RECORD OF DECISION

**NAVAL WEAPONS INDUSTRIAL RESERVE PLANT
BETHPAGE, NEW YORK
OPERABLE UNIT 2 - GROUNDWATER
NYS REGISTRY: 1-30-003B**

APRIL 2003 (REVISION 1)

**COMMENT RESPONSES FROM ENGINEERING FIELD ACTIVITY, NORTHEAST
REGARDING
FINAL NAVY RECORD OF DECISION FOR GROUNDWATER (JANUARY 2003)
NAVAL WEAPONS INDUSTRIAL RESERVE PLANT (NWIRP) BETHPAGE, NEW YORK**

CONTRACT NUMBER	OWNER NUMBER
APPROVED BY	DATE
APPROVED BY	DATE
DRAWING NO. FIGURE 2	REV 0

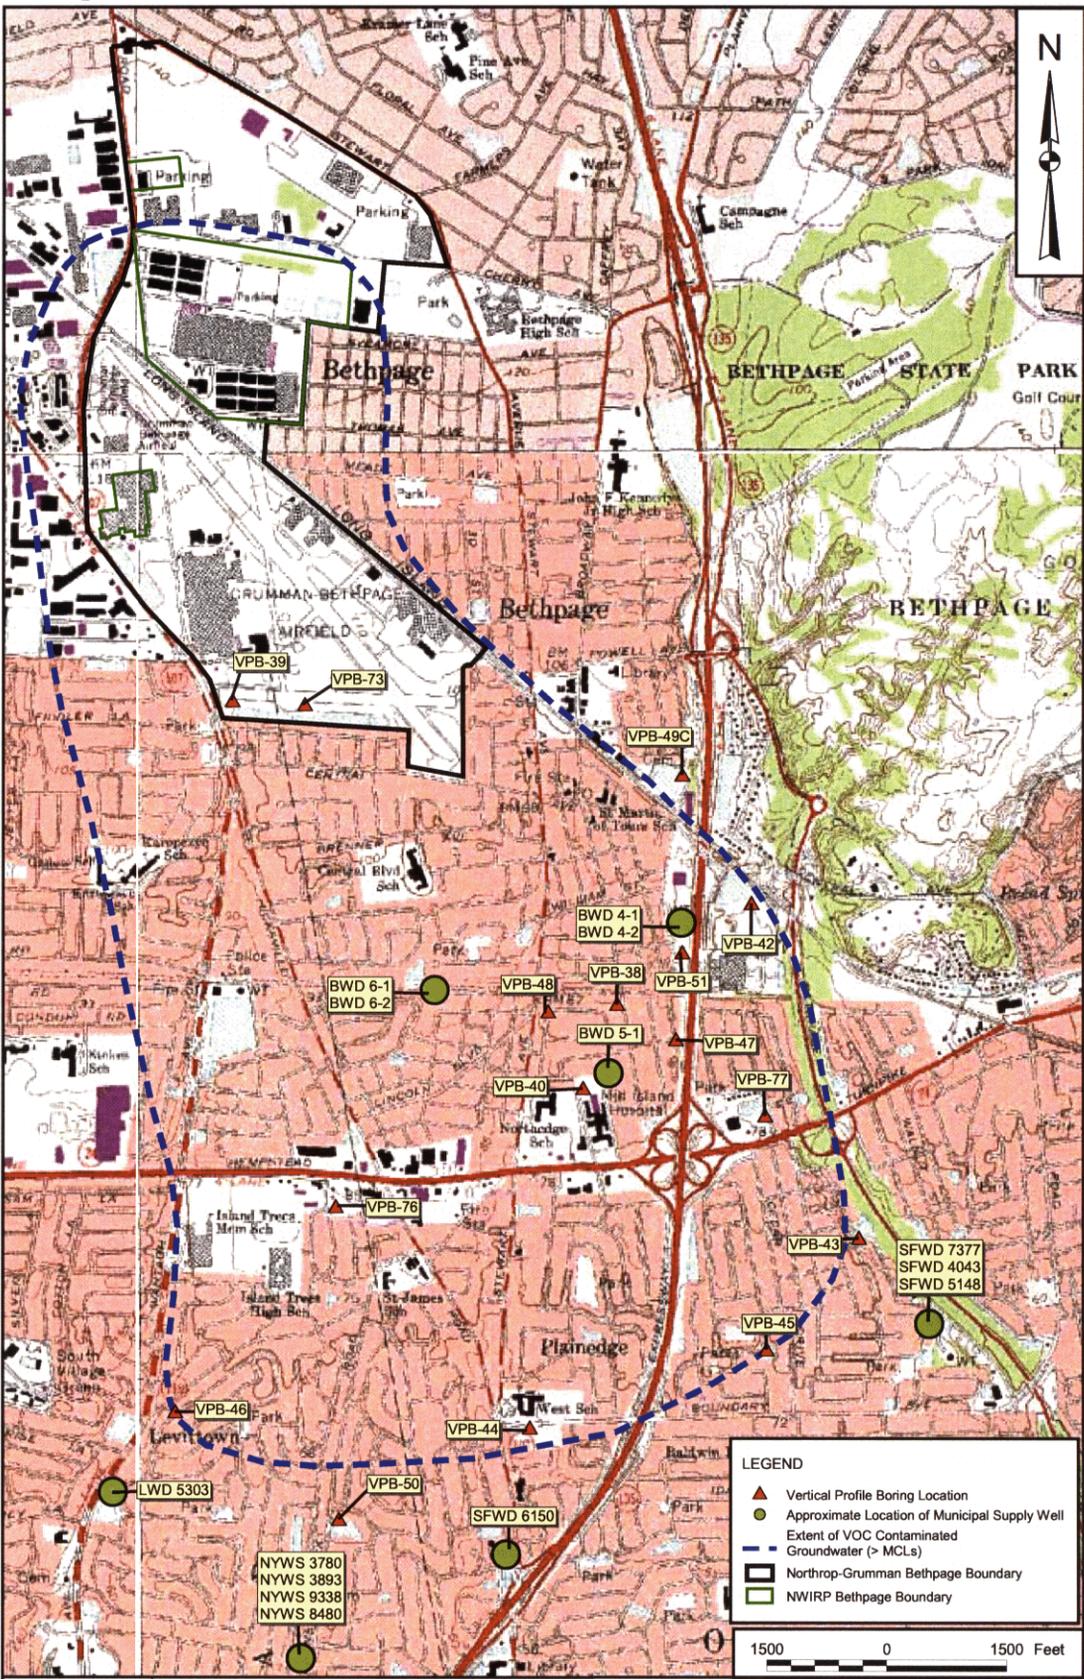
9. Pages 5 and 6 of the ROD identify the former disposal areas as "Area 1," "Area 2" and "Area 3." These areas are described as "Site 1," "Site 2" and "Site 3" on Figure 2 and on page 11. Identification of the area should be consistent.

RESPONSE TO 9: References made to the former disposal areas will be revised on pages 5 and 6 to match the term "Site" used on Figure 2.

CONTRACT NUMBER N4037		OWNER NUMBER
APPROVED BY	DATE	
APPROVED BY	DATE	
DRAWING NO.	FIGURE 3	REV 0

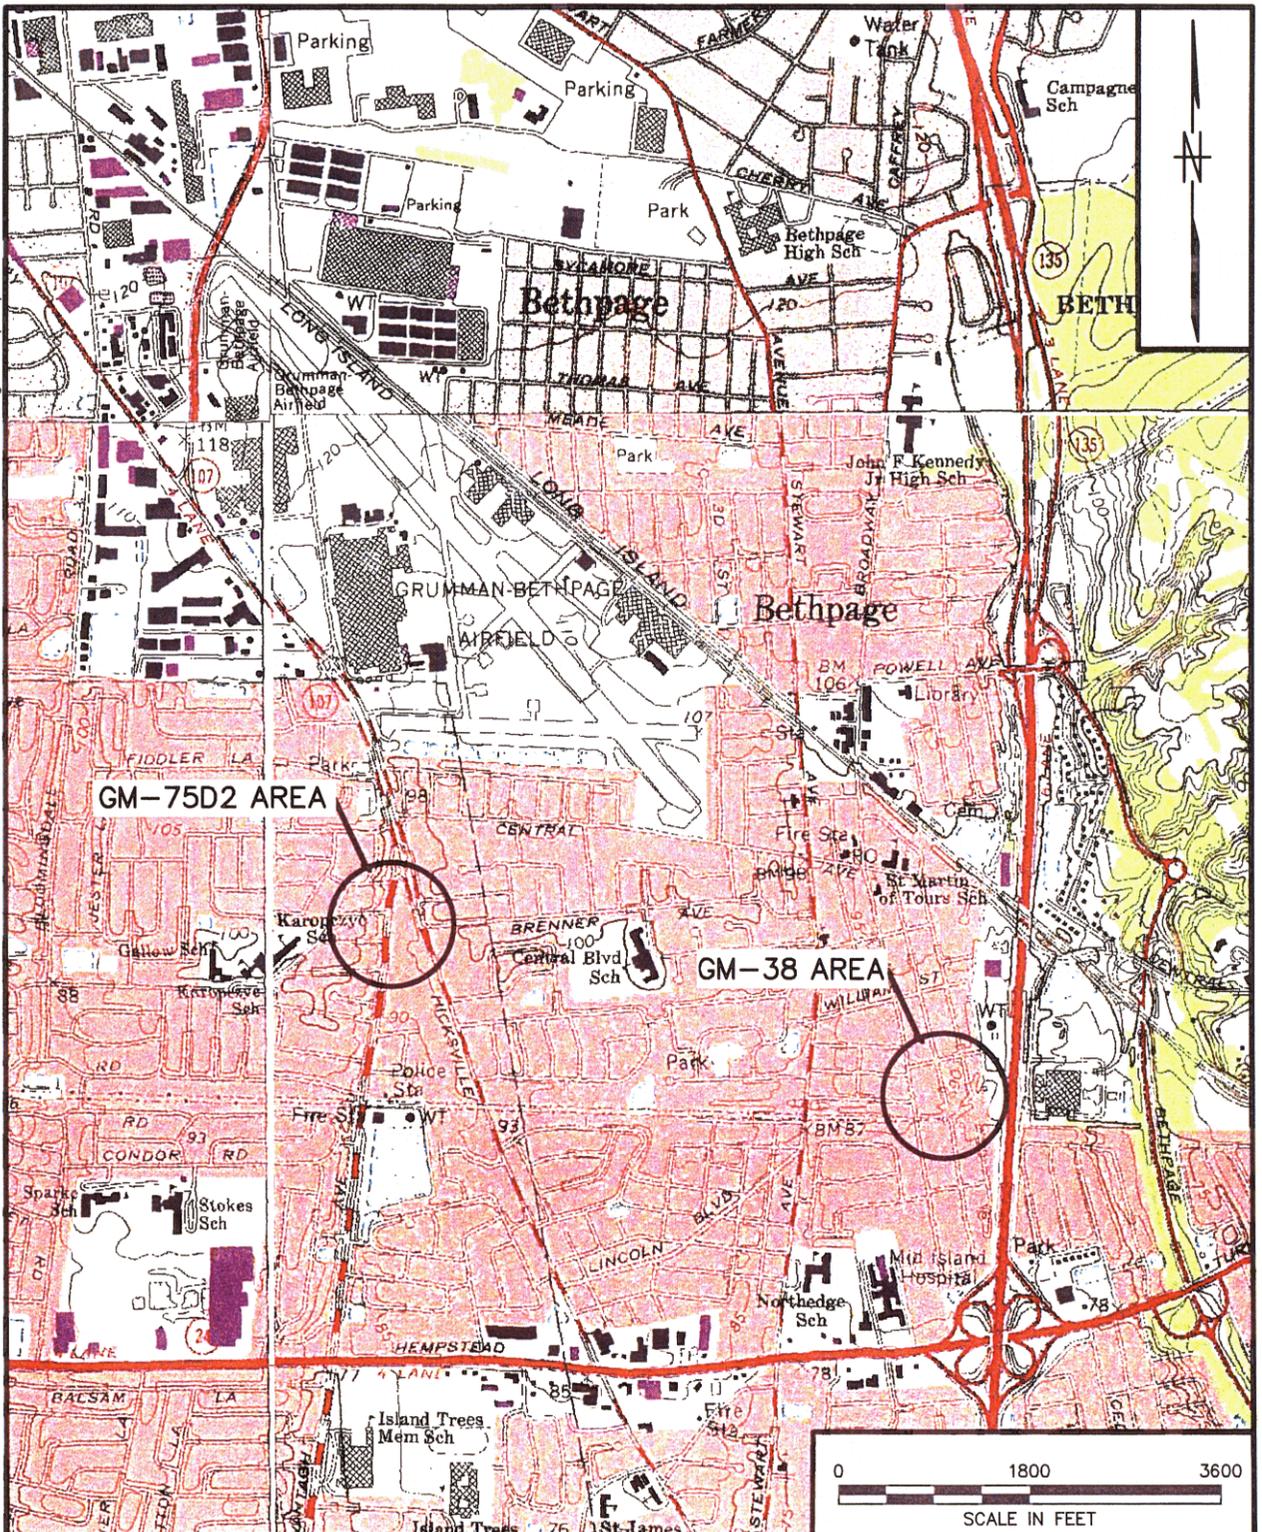
8. Figure 3 should be modified so that the extent of the groundwater plume can be clearly identified, even on a photocopied page.

17. Figure 3 should be revised to better illustrate the extent of the VOC plume. The plume extent is not apparent in the figure supplied.

- Figure 3 - Based on the latest data, this figure does not appear to accurately and clearly show the extent of VOC contaminated groundwater (>MCLs).

- Figure 3 - This figure intends to delineate the extent of groundwater contamination above the MCL. The figure is very unclear, and the delineation line cannot be seen. We recommend that the figure be revised so that the necessary information can be more easily seen.

RESPONSE TO 8: Comment noted. A revised Figure 3 was inserted.

RESPONSE TO 17: Agreed. Figure 3 has been modified.

RESPONSE: Figure 3 has been revised to better reflect the extent of the groundwater contaminant plume. However, no change in the outline was made since the figure provides an accurate representation of the extent of the groundwater contaminant plume.

RESPONSE: Figure 3 has been modified.
